SPI 576
Page 4 of 6
Rev. "B"
April 12, 1968

SPI 585
Page 1 of 1
April 20, 1964

SPI 606
Page 1 of 1
February 6, 1965

SPI 610
Page 1 of 1
February 25, 1965

FIG. 1. VALVE BODY, WITH COMPONENTS INSTALLED IN EACH BORE - CROSS-SECTION VIEW

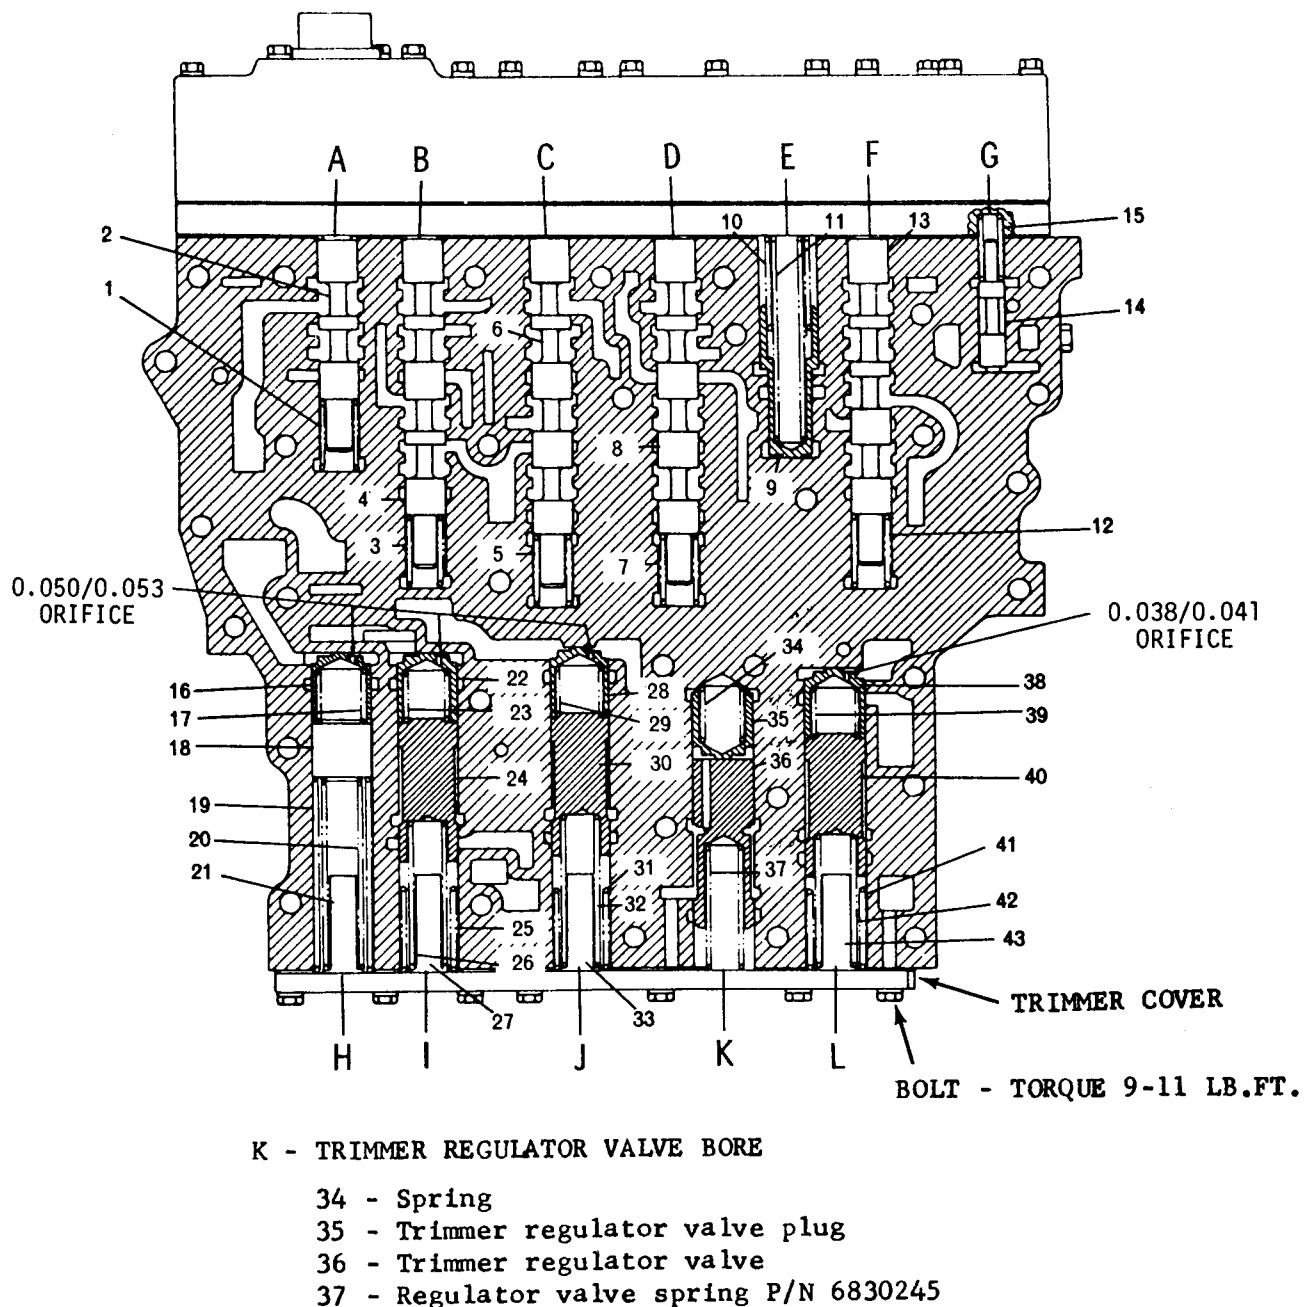
To improve the shift characteristics of the 2nd to 3rd and 3rd to 2nd drive gears in the subject transmissions, the trimmer regulator valve spring has been eliminated. Removal of this spring improves the hydraulic cycle rate of this transitional shift providing a smoother shift between these drive ranges. This spring being removed is item 37 located in the "K" bore indicated in Figure 1.

To avoid possible misassembly of trimmer springs, the top spring, item 34, is being replaced with another spring at this time to provide common spring usage at top of all trimmer bores. Thus, springs (items 17, 23, 29, 34 and 39) will all be the same at these locations.

1. Loosen (not remove) evenly all bolts retaining trimmer cover at the bottom of control valve body assembly enough to lower (not remove) cover. Refer to Figure 1.
2. Now, slip spring 6830245 out of the "K" bore of the control body.
3. Retighten all bolts evenly to a torque of 9 to 11 lb. ft.

Figure 1. 6835408—Body, Range Control Valve

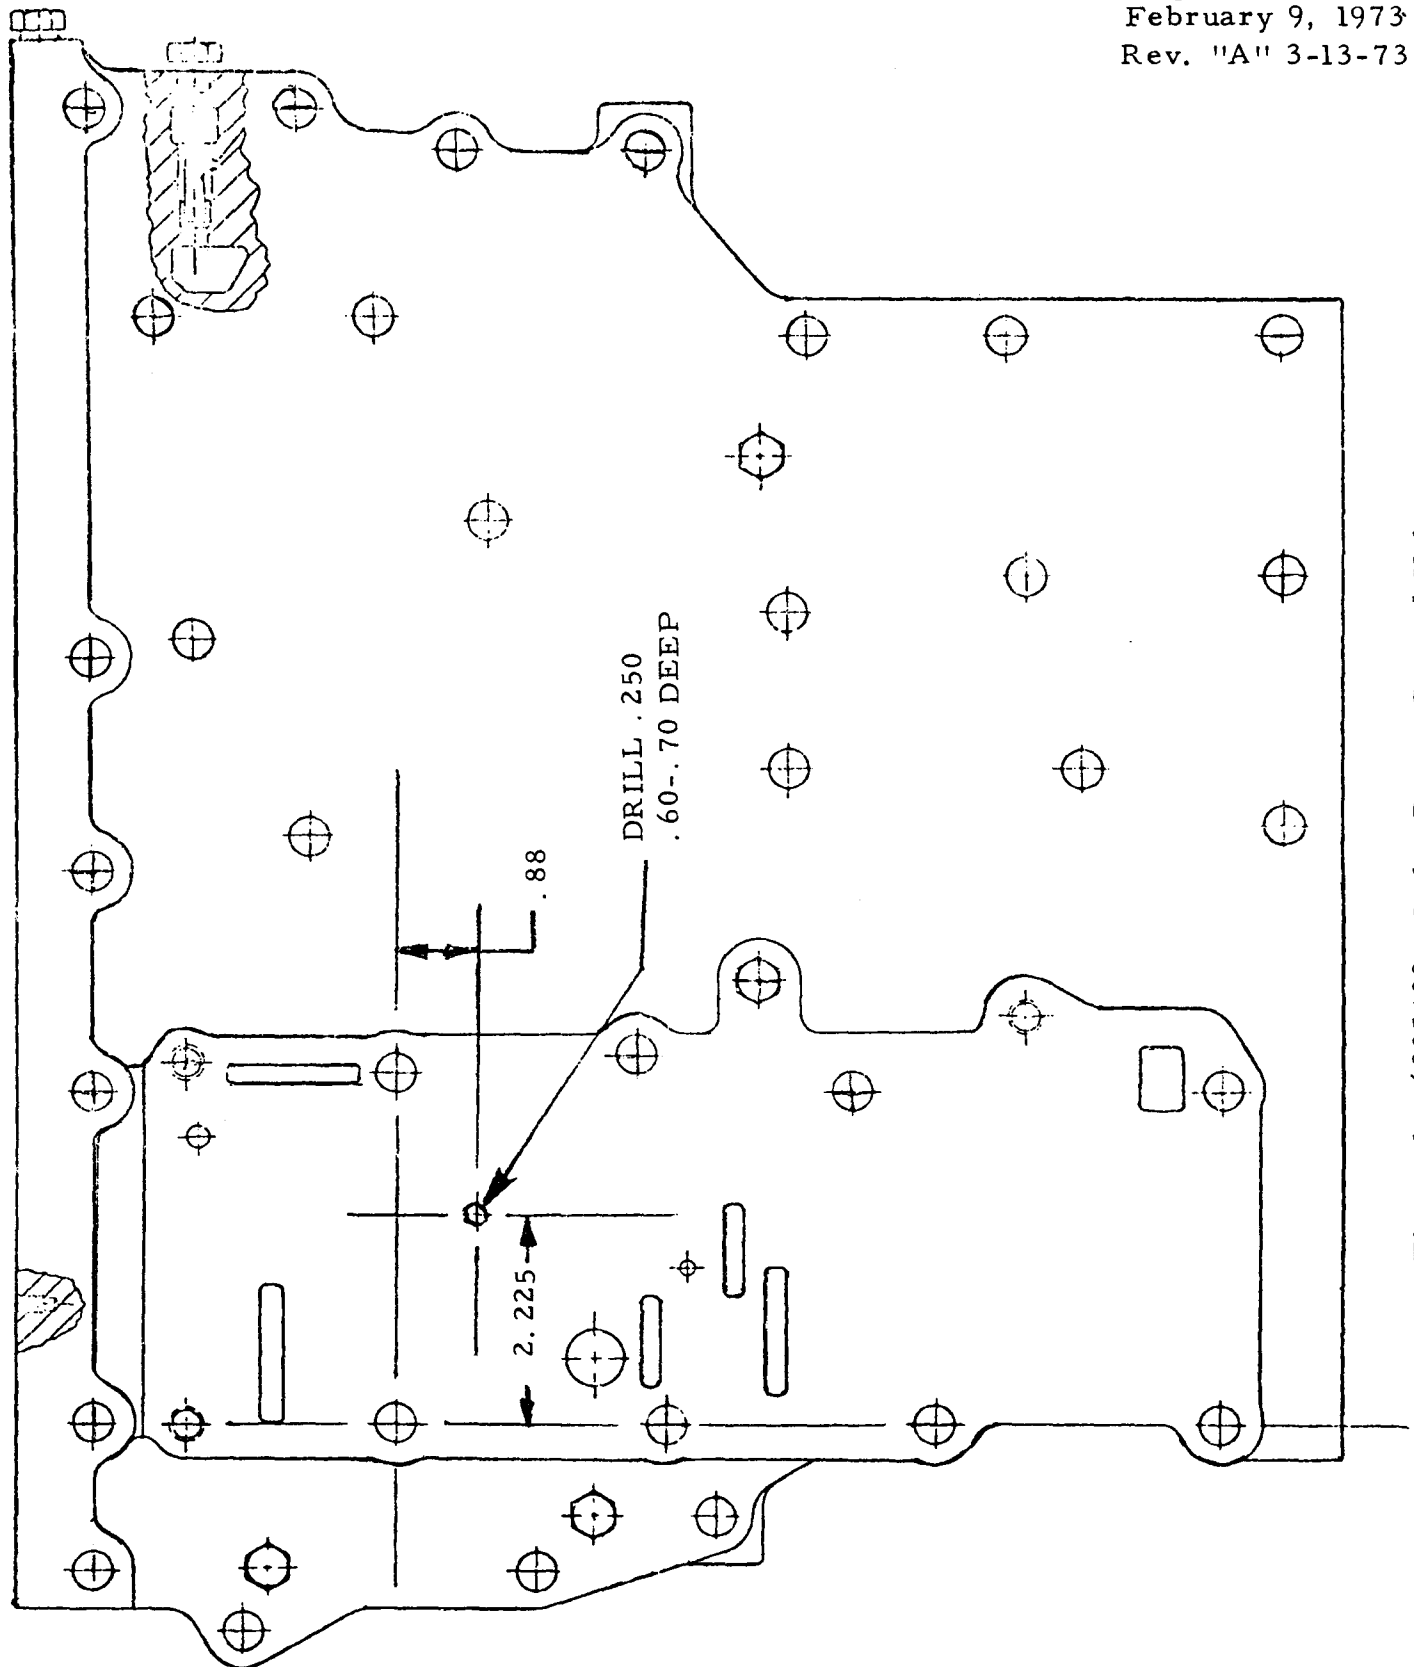
1. Replace 1st range valve body assembly P/N 6779851 with new 1st range valve body assembly P/N 6838903.
2. Rework control valve body assembly P/N 6835408 by drilling a 0.250 inch diameter hole to a depth of 0.60 to 0.70 inch at the location indicated in Figure 1. Be sure to remove all drill debris.

Figure 2. 6835415—Plate, 1st Range Oil Transfer

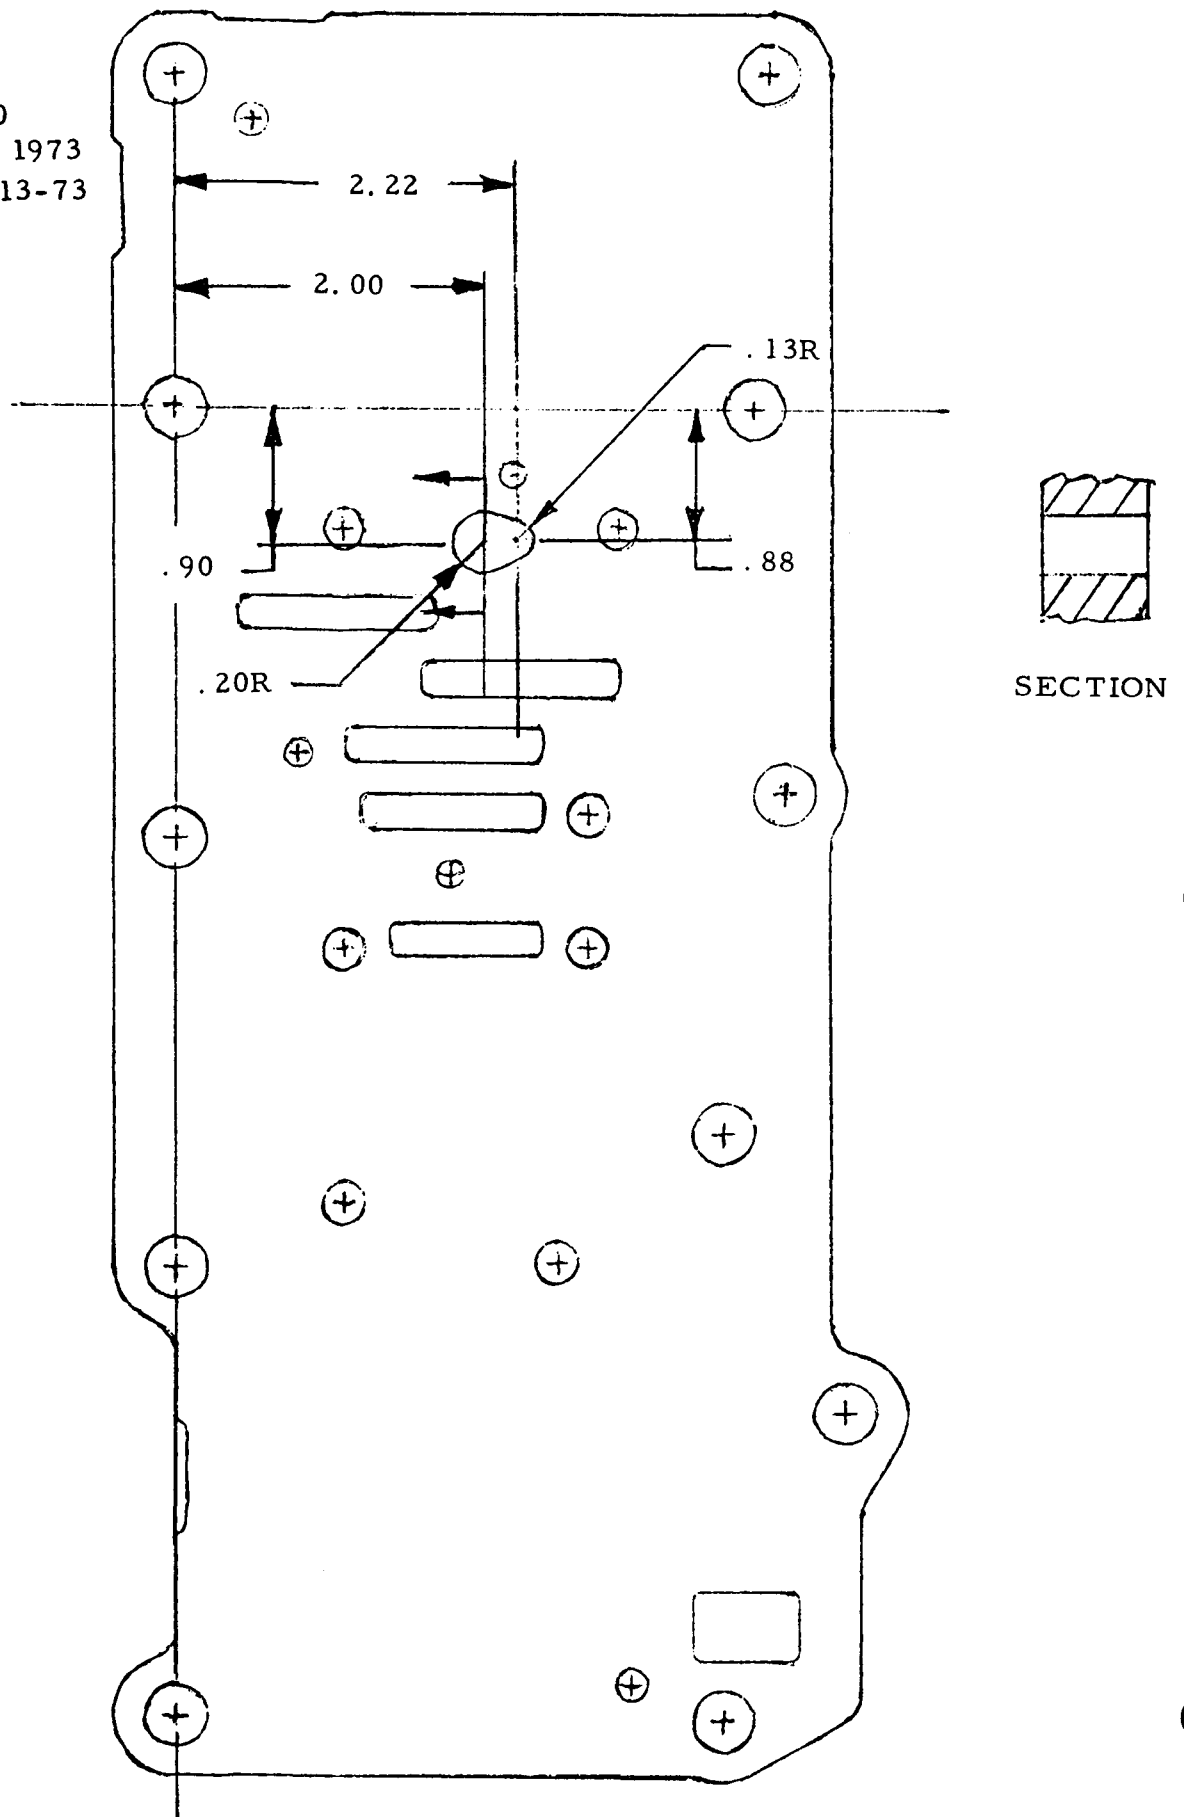
3. Rework 1st range valve body oil transfer plate P/N 6835415 by machining the irregular opening through the plate at the location indicated in Figure 2. First, use a 1/4 inch diameter drill for the 0.13R area through plate where the 2.22 inch and 0.88 inch co-ordinates intersect and then use a 13/32 inch drill for the 0.20R area by drilling through where the 2.00 inch and 0.90 inch co-ordinates intersect. Use a suitable file to complete the shape and form of opening as illustrated in Figure 2. Be sure to remove all drill debris.

Figure 3. 6835416—Gasket, Transfer Plate

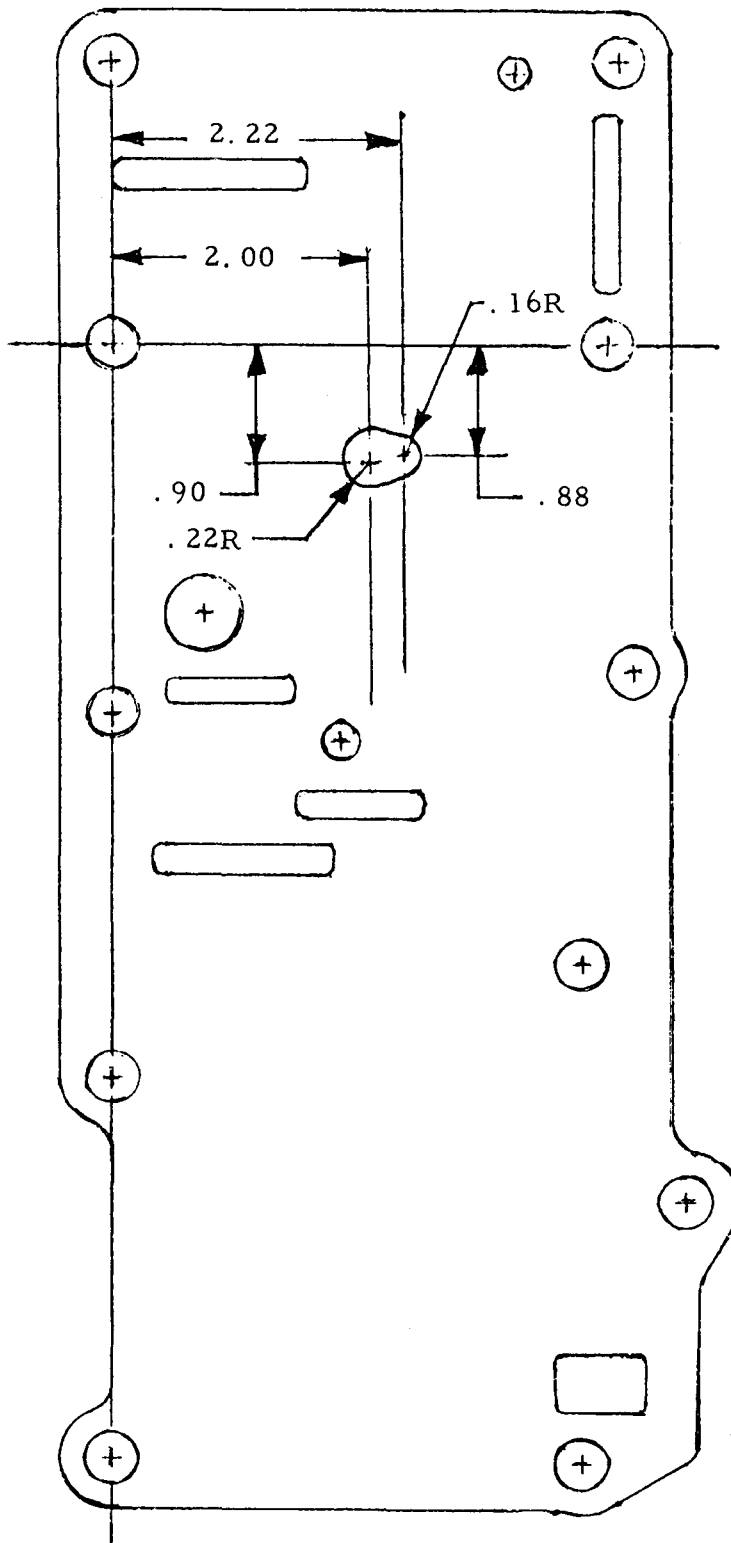
4. Rework a 1st range body transfer plate gasket P/N 6835416 by cutting out the irregular opening indicated in Figure 3. This is to match the opening made in transfer plate in Step 3 above, but should be slightly larger as dimensionally indicated. To obtain a quick pattern and location, the gasket could be placed on top of the reworked transfer plate and tapped lightly with a ball-peen type hammer or roller bearing.

Figure 4. 6835527—Gasket, 1st Range Valve Body

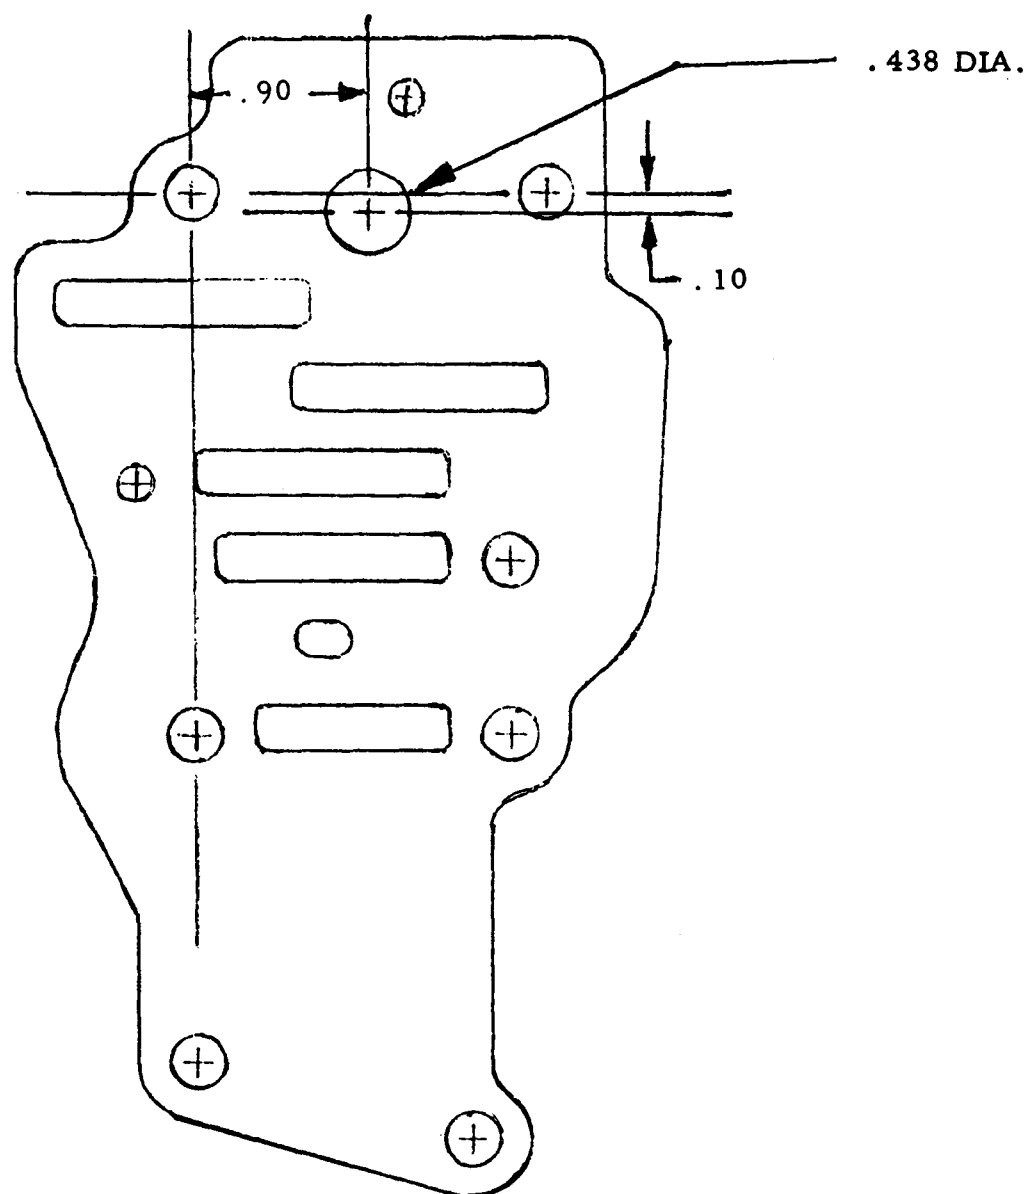
5. Rework a 1st range valve body gasket P/N 6835527 by adding a 0.438 inch diameter hole at the location indicated in Figure 4.
